SL-P120

Please use this manual together with the service manual for Model No. SL-P320, Order No. HAD8702603C0.

Notes: ★ Mentioned in this service manual are the differences from Model No. SL-P320.

Please file and use this supplement manual together with the service manual for Model No. SL-P120, Order No. HAD8703023A0.

• OPERATION P.C.B.

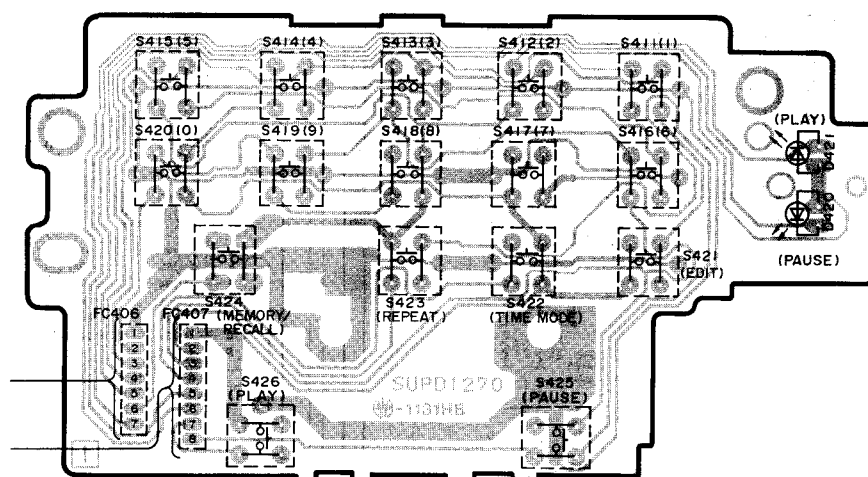
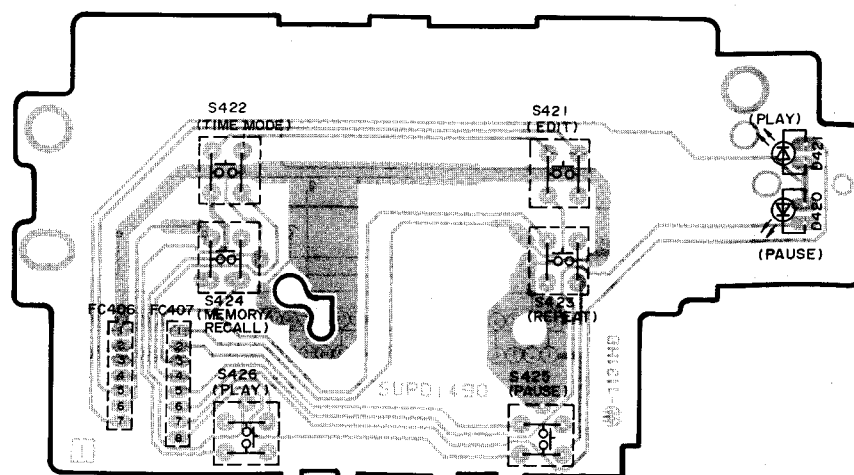
1. This product is not provided with remote control unit and remote control circuit on the main P.C.B.
2. This product is not provided with the numeric switches on the operation P.C.B.

■ SCHEMATIC DIAGRAM

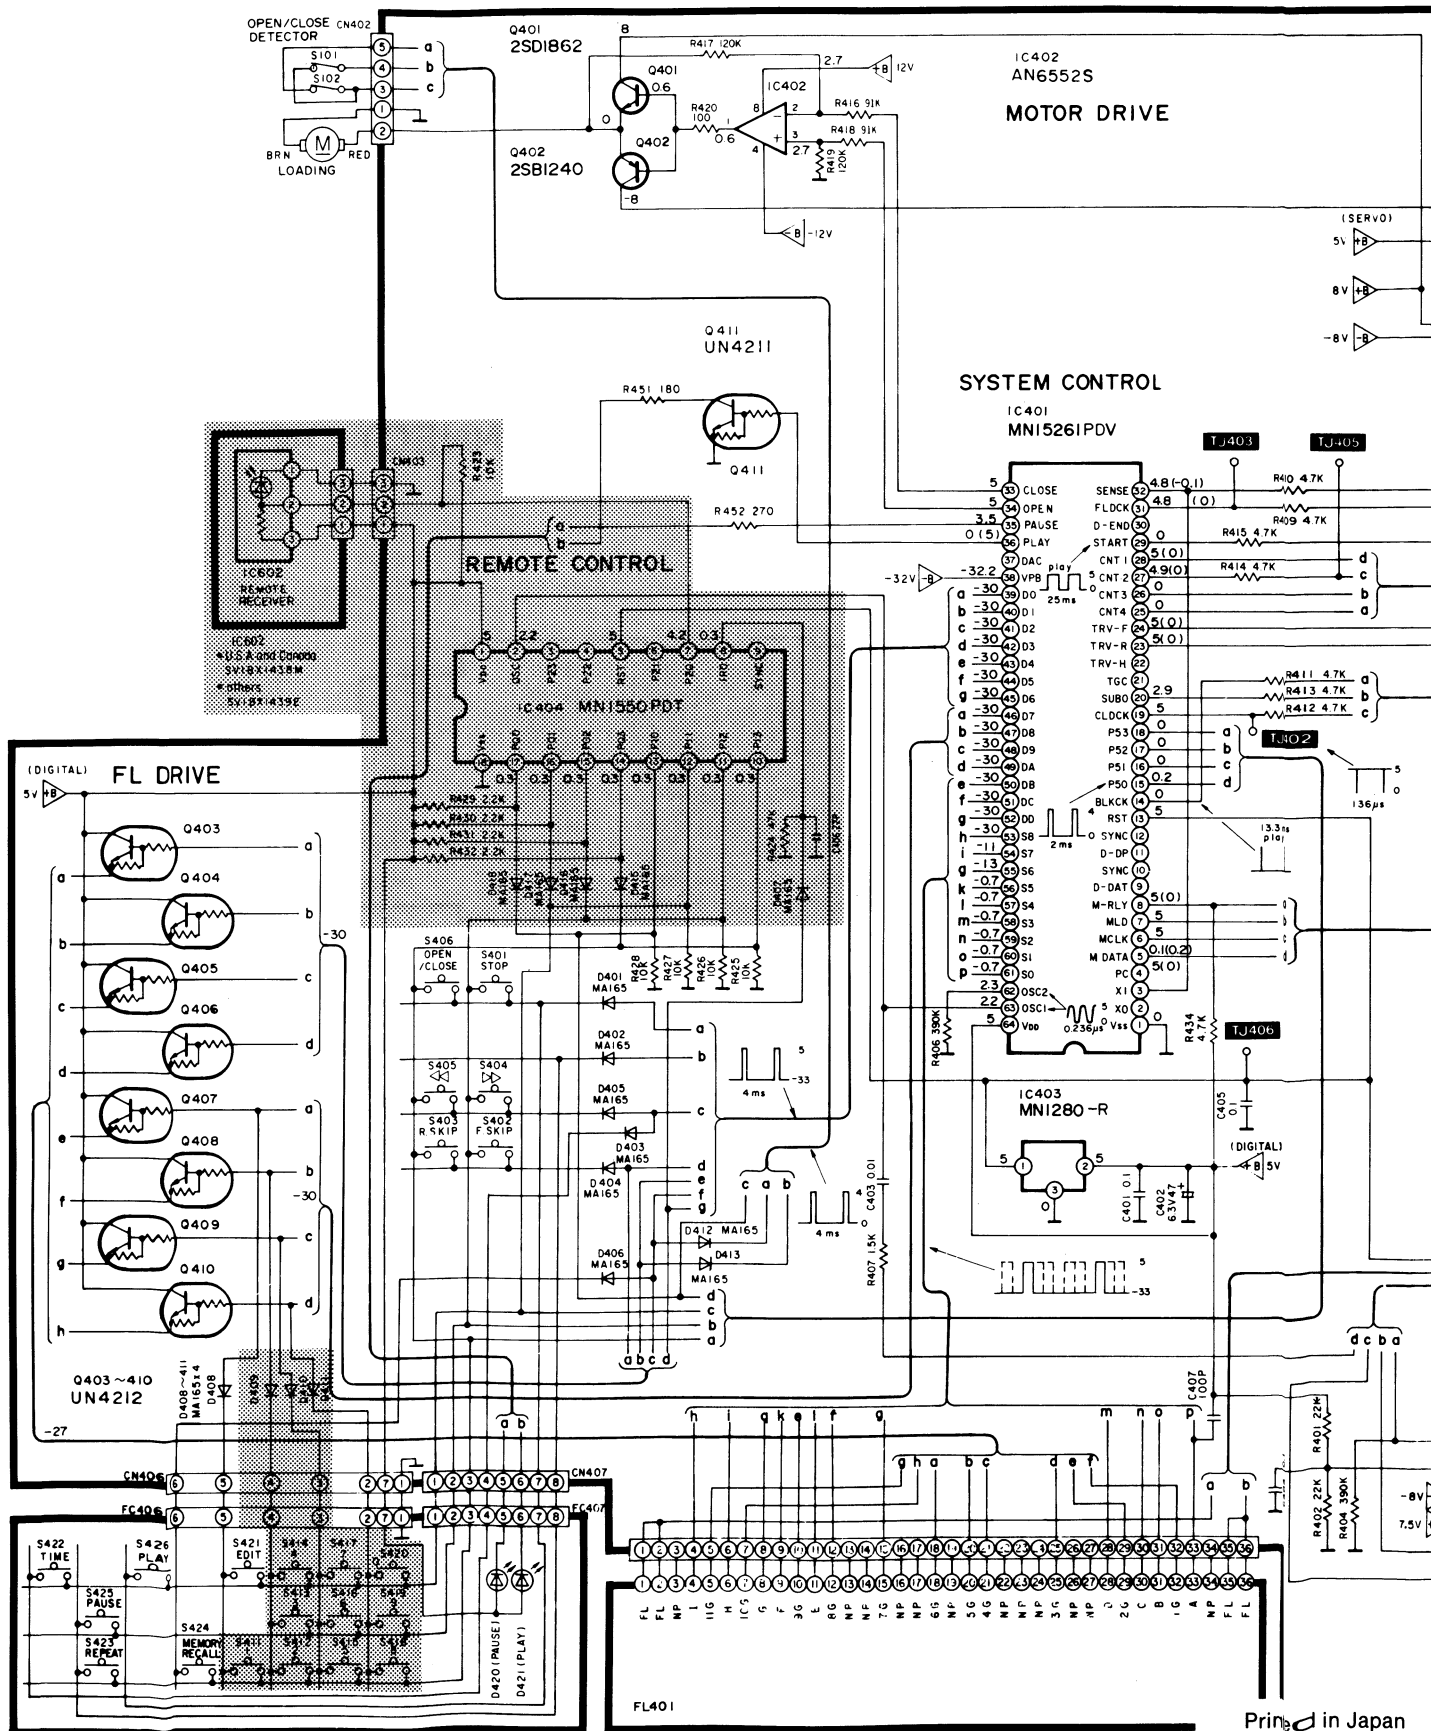
Note: This product is not provided with the parts in the following 2 circuitry in the shaded area.

1. Remote control circuit on the main P.C.B.
2. Numeric switches on the operation P.C.B.

■ SCHEMATIC DIAGRAM

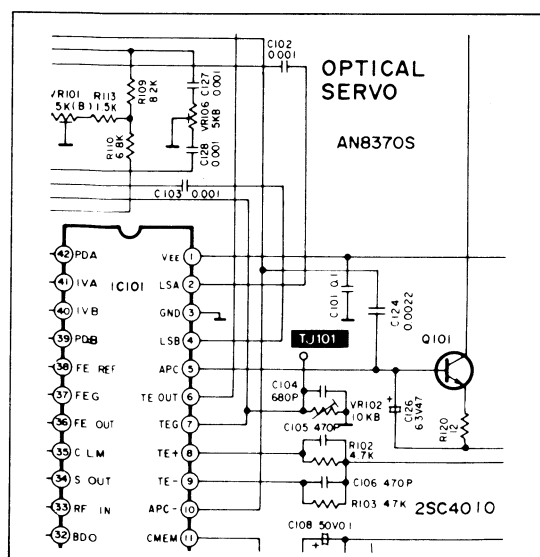
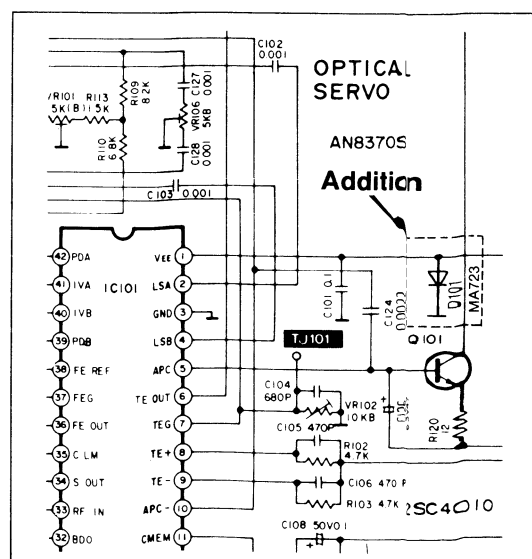
- This supplement has been issued to inform you that the optical servo circuit has been changed in units having serial number suffixes "C" or later. (Refer to "How to read the serial number" on page 2.)

Note: D101 (Diode, Schottky) has been added to improve the efficiency of the laser diode.

■ REPLACEMENT OF DIODE (D101)

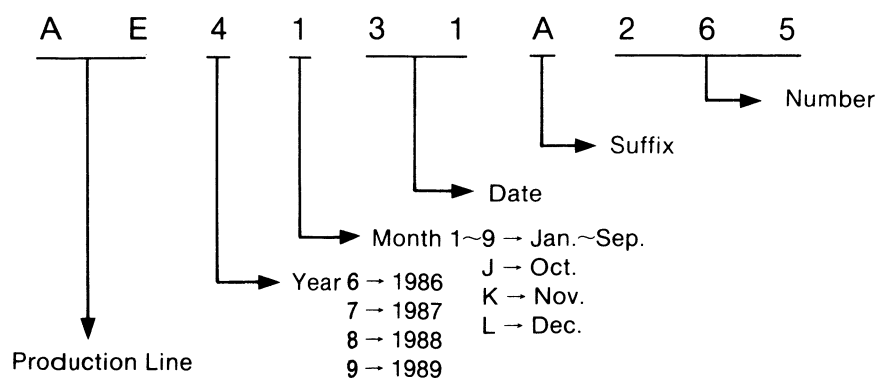
•As shown in the figure, the diode has been added on the parts side of the main P.C.B.

Ref. No.	Change of Part No.		Part Name & Description	Remarks
	OLD	➡ NEW		
DIODE				
D101		MA723	Diode, Schottky	Addition
